RE: **Lexus Parking Lot Expansion**
4811 Pan-American NE
Grading Plan Stamp Date: 3/15/19
Hydrology File: F17D102

Based on the submittal received on 3/18/19, this project cannot be approved for grading or paving permit until the following are corrected:

COVER SHEET
LEXUS PARKING LOT EXPANSION

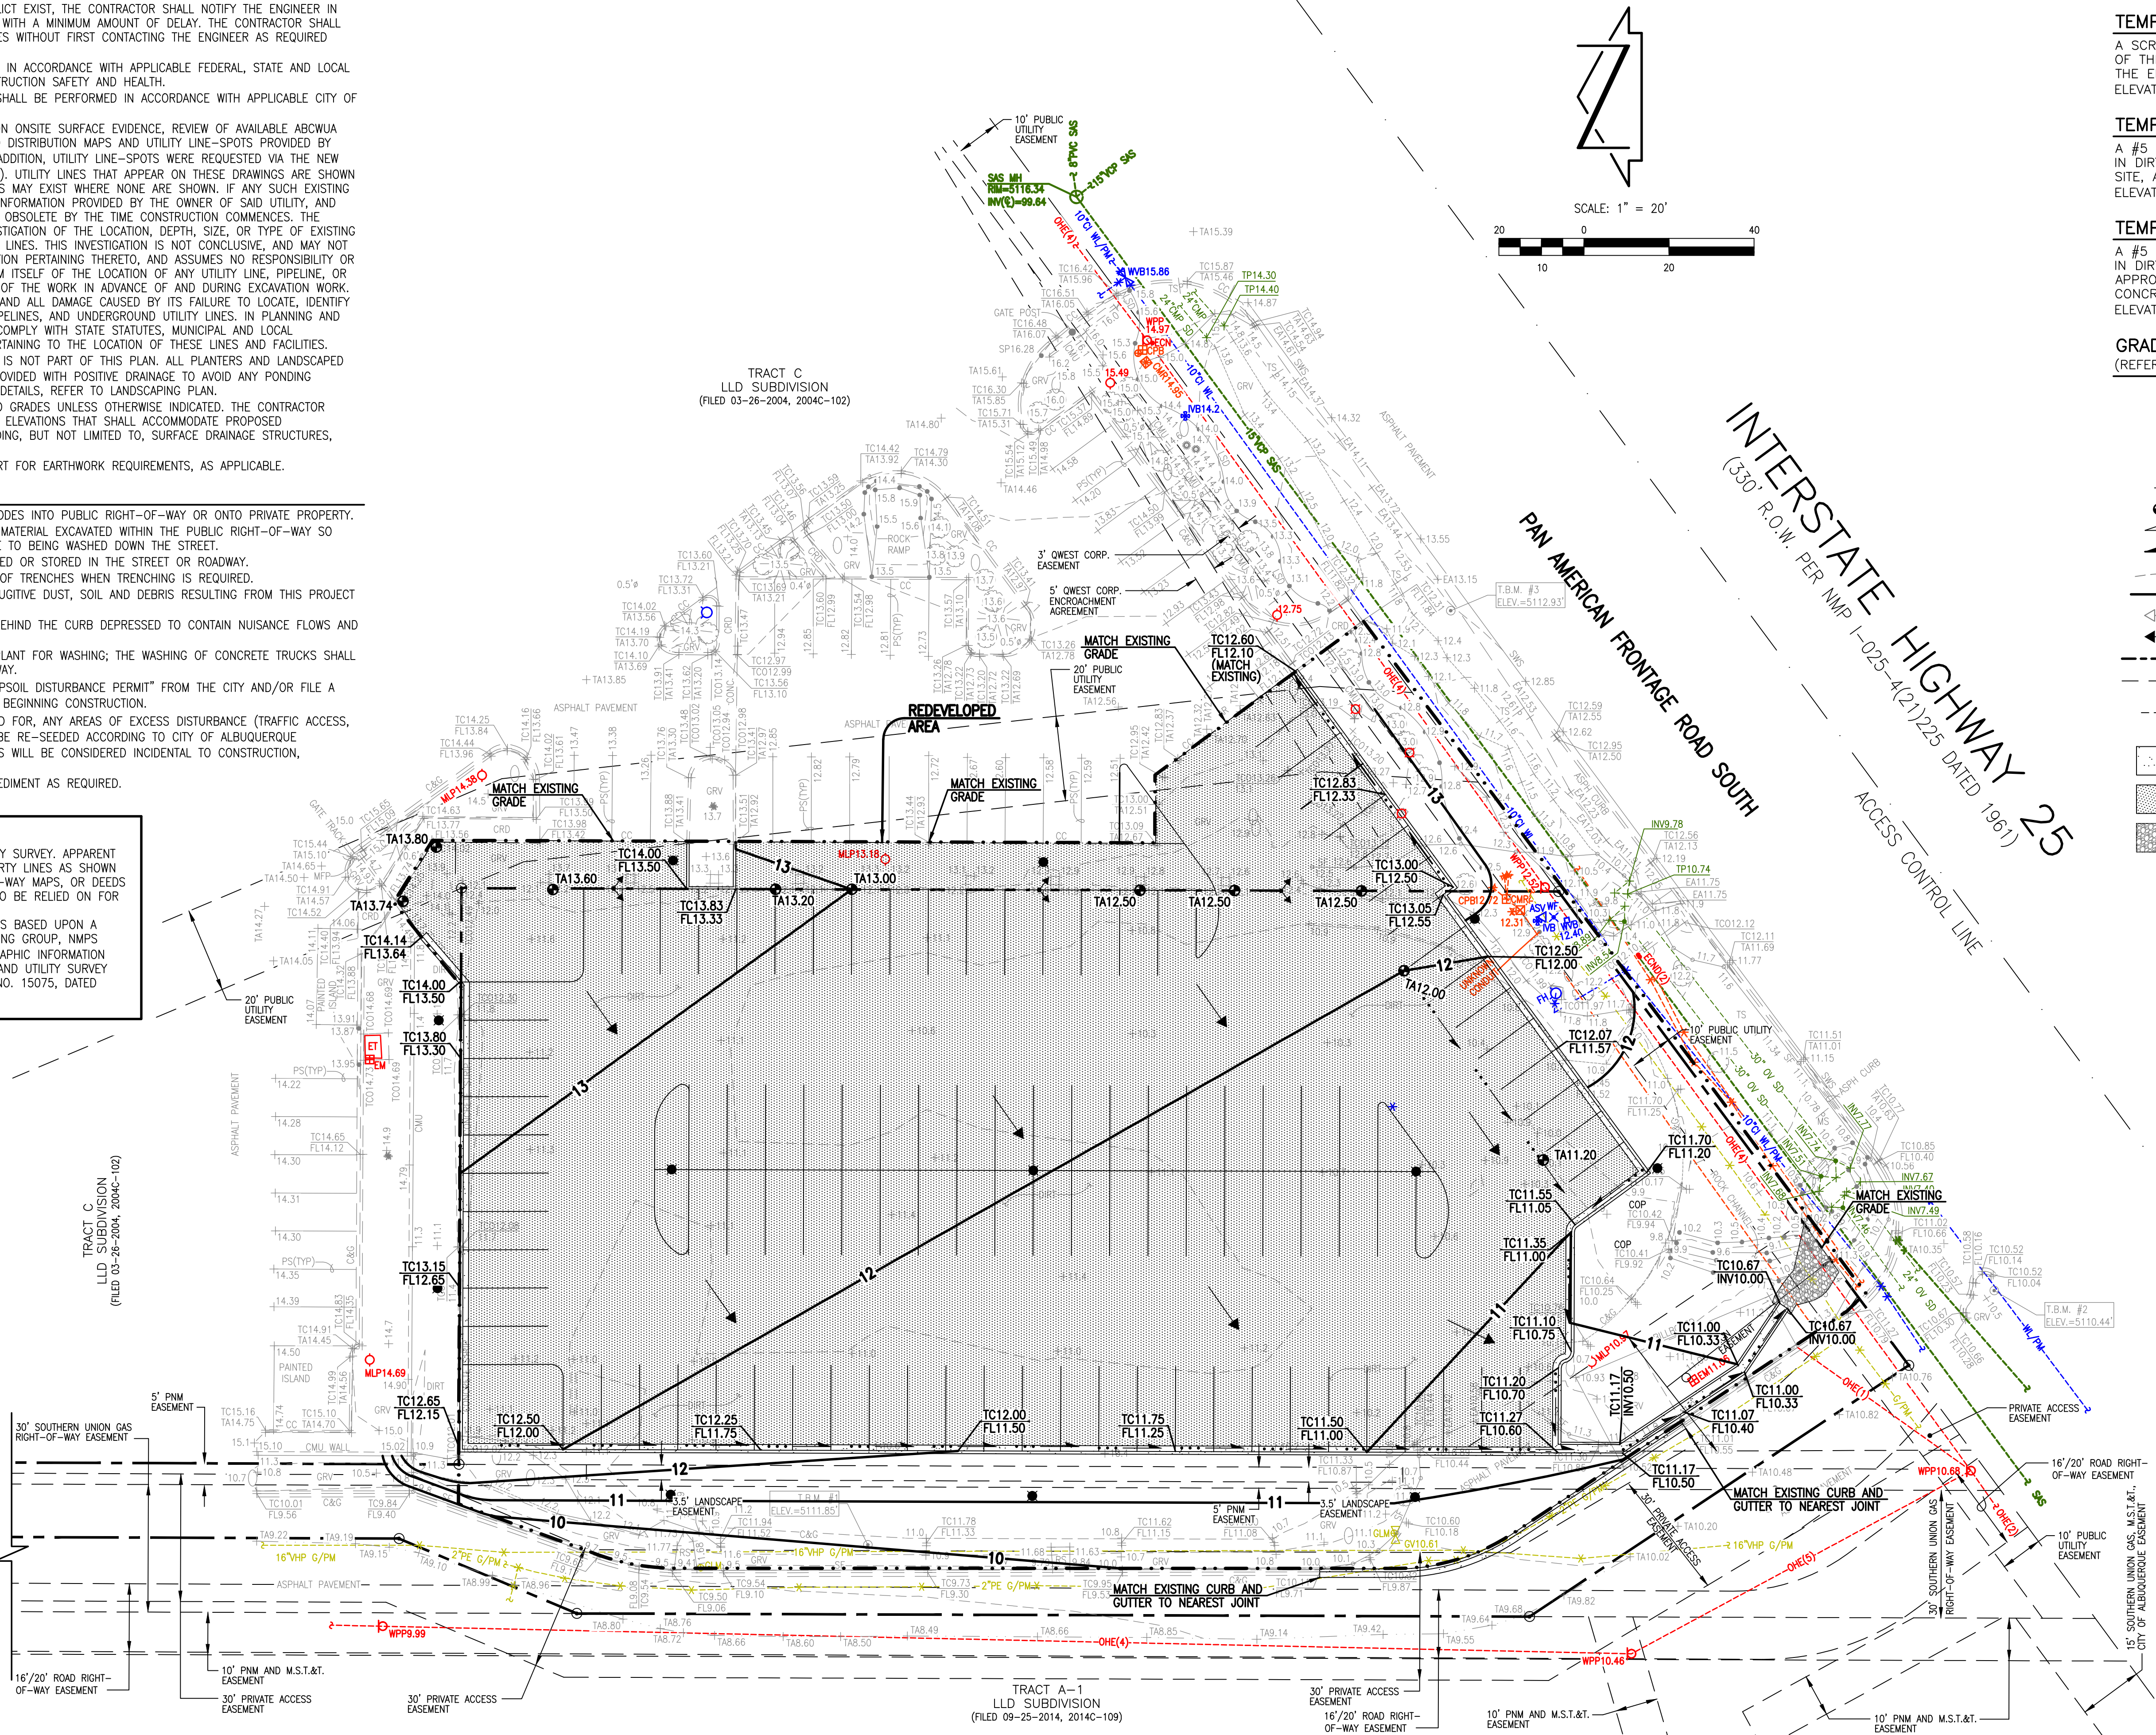
4. Hydraulic calculations are missing for the concrete rundown channel, no channel width is called out on plan view, and the plan view doesn't reference the channel section on C-104. Capacity (flow depth) also needs to be checked along the south curblin to ensure the 6" curb is high enough.

5. The rip-rap pad should be formed into a channel with its dimensions called out. You probably want a turn-down or cut-off wall where the concrete channel terminates, in case of scour there.
